Appl. No. 10/726,796
Amdt. dated December 30, 2004
Reply to Office Action of October 6, 2004

Amendments to the Drawings:

Remarks/Arguments

FIG.1

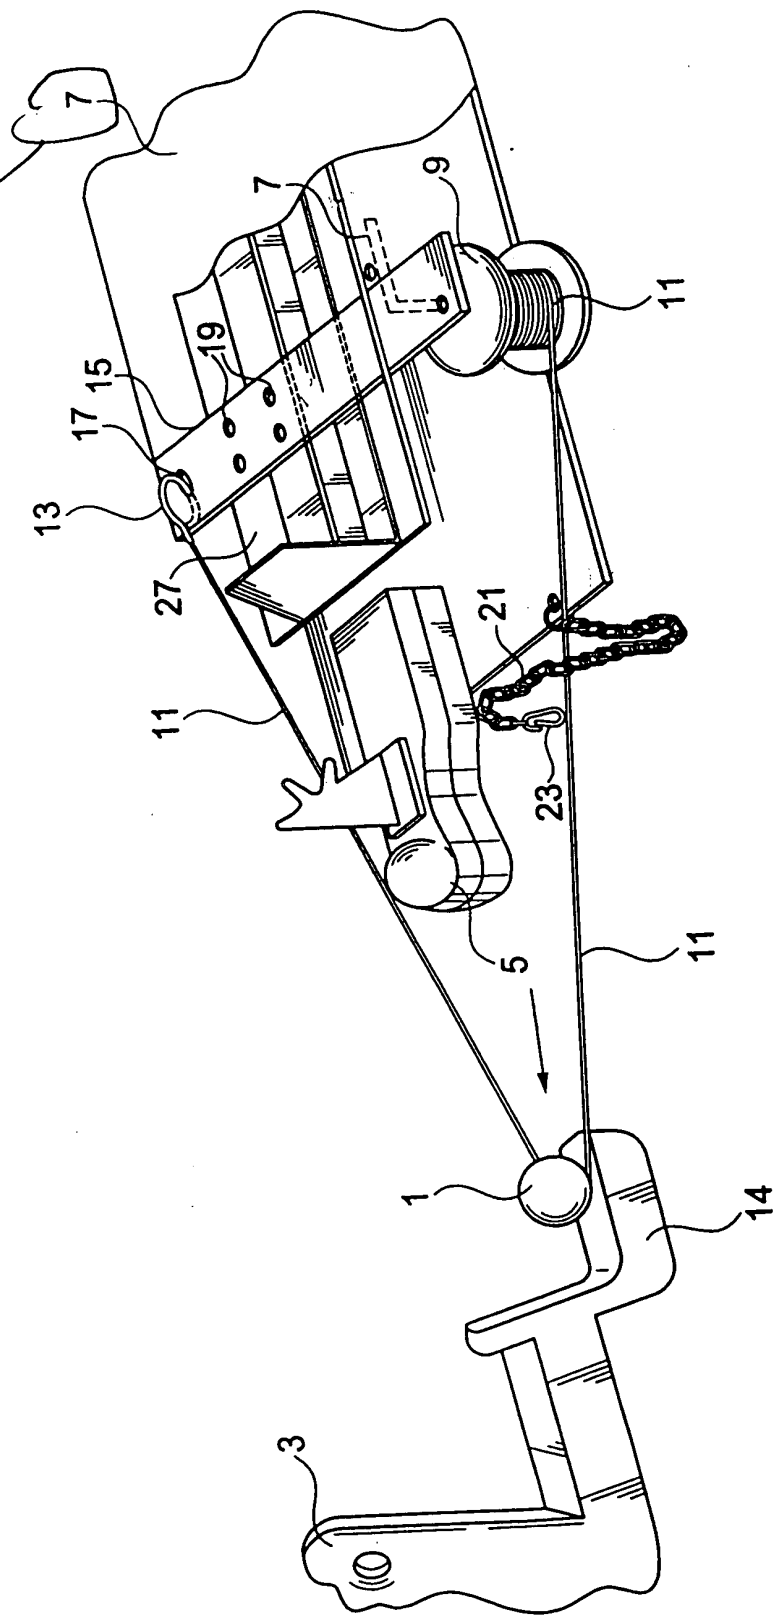
The attached drawing sheet includes changes to FIG. 1. This sheet replaces the original sheet that includes FIG. 1. In FIG. 1, one of the inadvertently duplicated references to item 7 has been removed.

*DUPLICATE
REMOVED*
